## Design Review Hearing

**Starbucks – 52<sup>nd</sup> Street**  
5200 W. Chinden Blvd.

DSRFY2024 - 0014  
September 16, 2024

**Site Plan**  
DSRFY2024 - 0014  
September 16, 2024

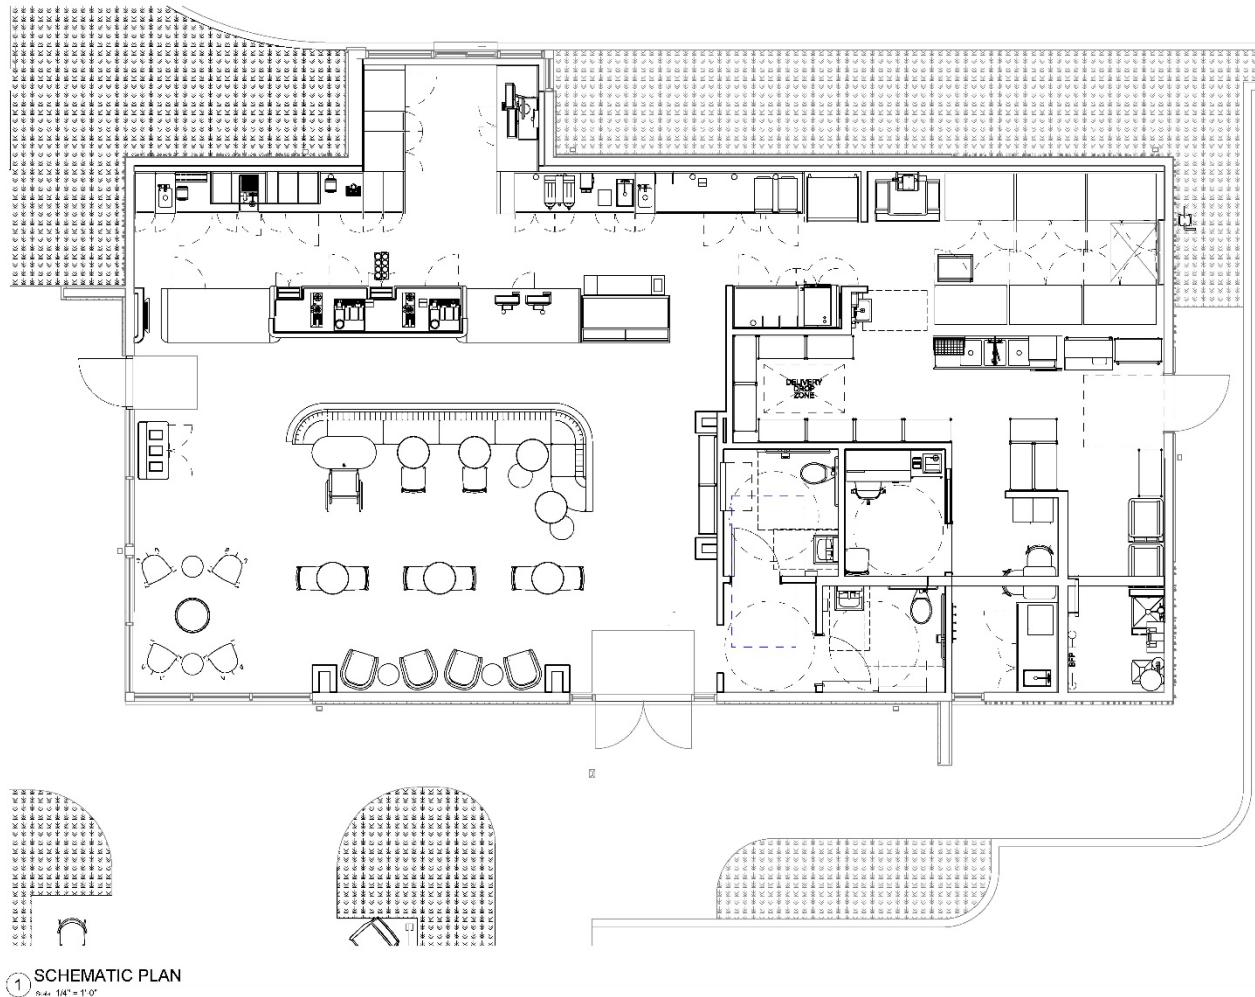
- *Staff Review: Adequate trash receptacles shall be provided that comply with the requirements set forth in section 8-4A-5, Outdoor Service and Equipment Areas, of this title. AND: Agency Comment: The waste truck will not be able to service at the proposed enclosure location. I recommend putting the enclosure at the entrance for service on 52<sup>nd</sup> St or swapping the enclosure for parking spaces.*

- *Stacking study not yet provided.*
  - **See site plan with stacking study and illustration.**
- *A minimum of one (1) outdoor trash receptacle shall be provided.*

- *A plaza has been provided; however, the square footage is not shown on plans.*
  - **See the updated Site Recap on the site plan.**
- *The south elevation faces W. Chinden Blvd and appears to provide at least 15% glazing and pedestrian elements. However, percentages are not given on the schematics. The east elevation facing E. 52<sup>nd</sup> Str. Appears to provide glazing and pedestrian elements at 15% or more. Calculations were not provided.*

- **As mentioned previously, the trash enclosure has been moved. The terminal view now looks toward parking and landscaping beyond.**
- *Handicap and Compact parking spaces: Stall width and depth unknown.*

- **See the updated site and landscape plans with the new trash enclosure location, and the email indicating Republic Services' approval of the new layout.**

- **See updated Site plan**
- *A restroom shall be provided for patrons. Floor plans not provided.*
  - **See floor plan**
- *ITD has recommended removal of the existing W. Chinden access upon redevelopment.*

- **See the updated site plan indicating dimensions of handicap and compact space dimensions.**
- *Bike parking facilities do not meet the code requirements. 1' wide by 3' tall shadow sun rack surface mounts are proposed. Code requires that bike parking spaces shall be a minimum of 6' long by 2' wide. And within 50' of the building's entrances.*

- **The bike parking has been moved closer to the entrance of the building to be within 50' of the entrance, and the parking space size has been shown at 6' by 2'-6".**

Elevations  
DSRFY2024 - 0014  
September 16, 2024

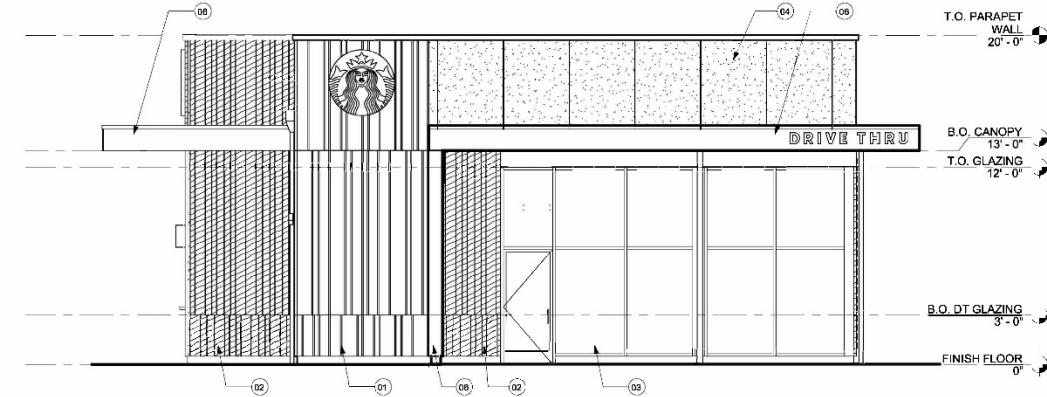
- **We will coordinate with ITD and ACHD on the required streetscape.**
- *The building's eastern and western façade and roofline are longer than 50'. Facades longer than fifty feet (50') (measured horizontally along the façade) should incorporate relief to perceived building mass through such features as wall projections or recesses, projecting windows, entrances, or other visual relief. Rooflines exceeding fifty feet (50'), should incorporate relief to the perceived building mass by providing roofline variation.*

East elevation  
glazing is equal  
to 29% of the  
façade.

South elevation  
glazing is equal  
to 54% of the  
façade.

- **See the glazing calcs on the elevation sheets in this presentation.**
- *Objective 3: Buildings shall be designed and constructed of quality materials. Discouraged Materials: Metal Siding.*

- **See the elevations and renderings showing visual reliefs along the facades.**
- *Terminal views within the site should be provided for landscaping, landmarks, or significant site features. The current site design shows the trash enclosure as a portion of the terminal view; however, this location is not viable for pick up services by Republic Services which will result in a change of site plans and terminal views.*
